MFN 08-154

**Subject: Response to Portion of NRC Request for Additional Information
Letter Nos. 125 and 135, Related to ESBWR Design Certification
Application – Human Factors Engineering - RAI Numbers 18.2-19,
18.2-20, 18.4-16 S02, 18.4-21 S01, 18.4-25 S01, 18.7-7 S02, 18.11-32
S01, 18.12-2 S01, 18.12-3 S01**

1. MFN 08-154 -Response to Portion of NRC Request for Additional Information Letter Nos. 125 and 135 Related to ESBWR Design Certification Application - Human Factors Engineering - RAI Numbers 18.2-19, 18.2-20, 18.4-16 S02, 18.4-21 S01, 18.4-25 S01, 18.7-7 S02, 18.11-32 S01, 18.12-2 S01, 18.12-3 S01

Figure 4 HFE Issue Safety/Risk Significance Methodology

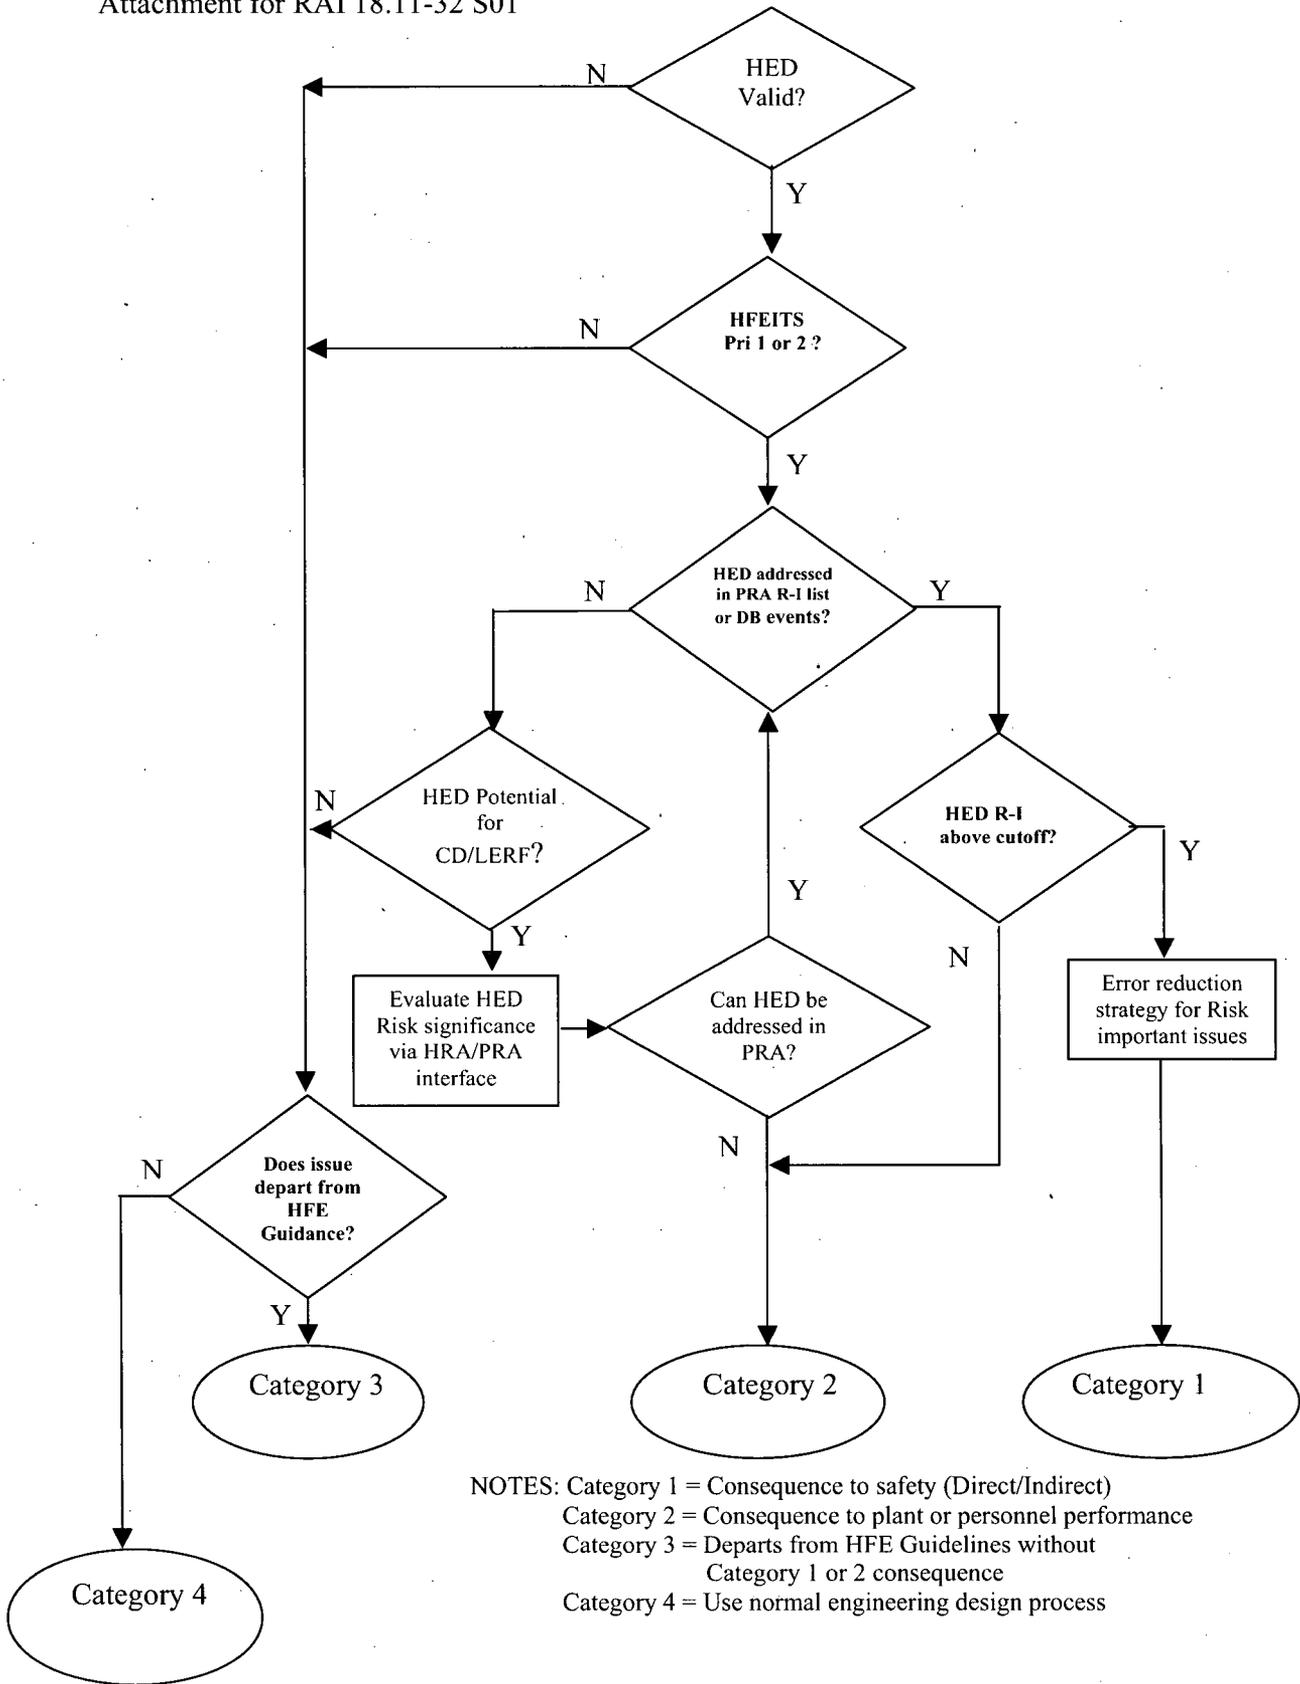
Section 4.6 NEDO-33226, Rev. 1, describes the resolution process for addressing HFE issues identified in V&V. The process is depicted graphically in Figure 4. GEH's process considers the impact on human performance and risk importance of issues from both quantitative (PRA) and qualitative perspectives. Where issues are found to qualitatively impact risk, the methodology seeks to determine if they can be addressed in PRA. While the methodology appears generally complete, there are three points of clarification requested.

- A. Is there a provision for justifying a discrepancy, e.g., deviation from the style guide with justification?*
- B. In Figure 4, at decision point 4, "Does Issue Meet Style Guide Requirements," actions are described for answering the question as "yes" or "no." However, for some issues meeting the style guide requirements is irrelevant. For example, an issue may be identified in integrated system validation, that a task could not be completed in time due to operator workload. In this case, the style guide requirements are not likely to be related to the issue. Instead, task reallocation to other personnel or automation may be the solution. Why is there no path to follow when the analyst concludes the issue is not related to style guide compliance?*

- C. Another point of clarification relates to the final solutions identified. They appear to be overly restrictive. For example, if an issue cannot be addressed in PRA, the analyst is guided to consider changing training, procedures, or staffing/qualifications. However, as in the example above, task redesign or increased automation may be warranted. Are the proposed solutions limited to those shown in the figure?*

Deviations from the style guide will be required and need to be justified. The style guide requirements statement will be removed from Figure 4 in order to provide a more inclusive review and follow-up flow path and to more accurately match DCD and NUREG-0711 requirements.

1. Figure 4 will be replaced in its entirety. See new Figure 4 Attachment.
2. Section 4.6 will be revised in its entirety and will include two new subparagraphs: See new Section 4.6 Attachment.
 - 4.6.1 Evaluation of HFE Issue Safety and Risk Importance Category 1 and 2
 - 4.6.2 Normal Engineering Processing Category 3 and 4.

As shown in Figure 4, if the HFE issue is safety or risk-important, a risk reduction strategy is determined. For example, if ~~(e.g., the issue addresses design basis event assumptions, or is addressed in the ESBWR PRA is in important PRA accident sequences, or appears in the importance measures listings of the PRA models), and is addressed in the ESBWR PRA,~~ a risk reduction strategy is determined. ~~it is safety or risk important.~~ The ~~Priority Category 1 issues is~~ are then closed out using all methods for risk reduction. Design change resolutions of HED issues might involve implementing as changes to plant features such as adding redundancy or diversity, making a system design change, or revising the S&Q plan indicated in the lower right side box to ensure that the issues risk contribution is below the cut off values for the risk importance measures¹.

Also, ~~as shown in Figure 4 is a path for qualitatively evaluating potentially risk important HFE issues that are not explicitly addressed in the PRA. Each , if the HFE issue is is qualitatively assessed not addressed in the ESBWR PRA as potentially risk important via a qualitative description and there is increased potential for an increase of in frequency of core damage/large early releases (CD/LERF),).~~ For example, the HFE issue ~~this could involve , e.g., unsafe an unsafe conditions, a technical specification violation, a contribution to common cause and dependencies, dependencies with other HFE issues that impact component reliability, system availability or accident sequence frequency.~~ Then the issue is evaluated for risk significance via HRA/PRA and reanalyzed for risk importance as shown in Figure 4.

Category 3 and 4 HED issues are not expected to be risk significant, but depart from HFE guidance or impact normal work activities. Figure 4 also shows that if the HED the issue is not in HFEITS Priority Category 1 or 2, not addressed in the design basis accidents or in the PRA, and does not qualitatively increase the potential for core damage/large early releases, and the issue does not conform to style guide violate any HFE guidance, it can be closed out by using Priority Category 3 or 4 resolutions. Category 3 resolutions include solution changes to HSI design such as color, display screen layout, navigation level, modifications to the plant, task redesign and other changes to enhance the HSI. Category 4 resolutions to HED issues are typically justified as being addressed as part of the normal design engineering process. Some issue resolutions are addressed by establishing situation or parameter to monitor in the Human Performance Monitoring program operated by the operating utility. Resolutions in all categories potentially contribute to HPM programs.
